R0019108 Zip Gate Opener for RS Automation Gearbox

Details on the R0019108 Zip Gate Opener Assembly

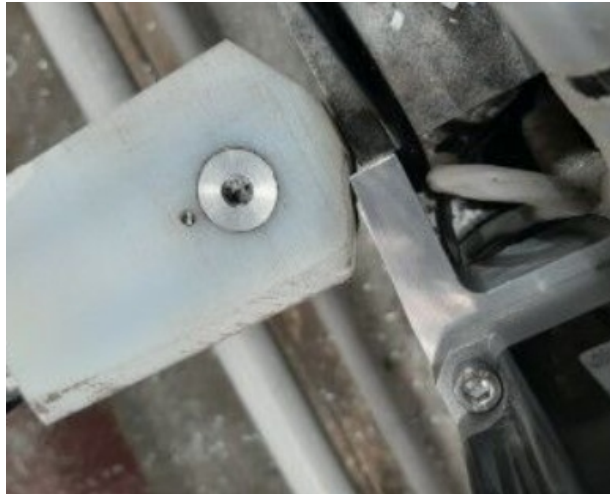
When fitting an RS Automation motor on an X axis, a larger diameter gearbox is required. If fitted to a machine with a zip gate system, this creates a problem with the gap needed for the Zip gate shafts - it is not wide enough.

Original solution was to supply shorter Zip gate shafts, but this did not solve the entire issue, as the gearbox width is still too large, particularly when the zip gate opener is added. To overcome this, a flange for the gearbox was designed to become the zip gate opener. Issues had to be overcome for the zip opening height

This was overcome by reducing the gearbox plate mount width to drop the entire gearbox body below the zip gates

The addition of the rear stainless gate opener allows the opening dimension to be correct and overcome this issue
